Access Compliance Report Public Rights-of-Way (Curb Ramps)

Main Street: VANDERLIP_AVE Cross Street: BRENAN_WAY Location: SW

ADA ID: RPAT211006092644 Ramp Type: Type 1 - Perpendicular Initial Pass/Fail: Pass Overall Compliance: No Severity Score: 19

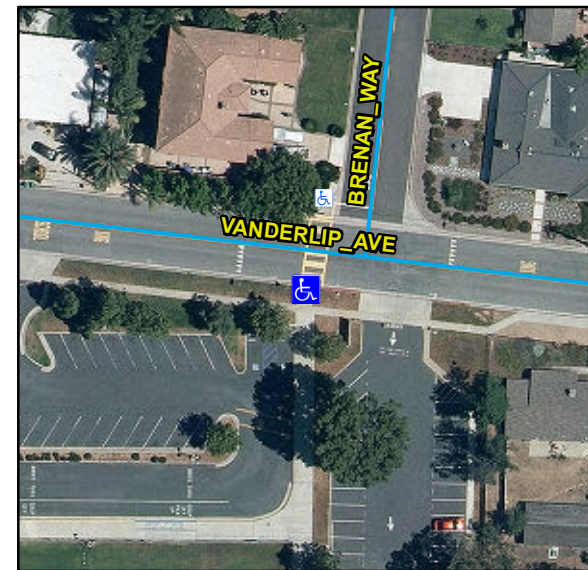
R304.2.2, R304.2.1, R305, R304.5.4, STD 1115

Remove & Replace Entire Ramp. Remove & Replace Gutter.
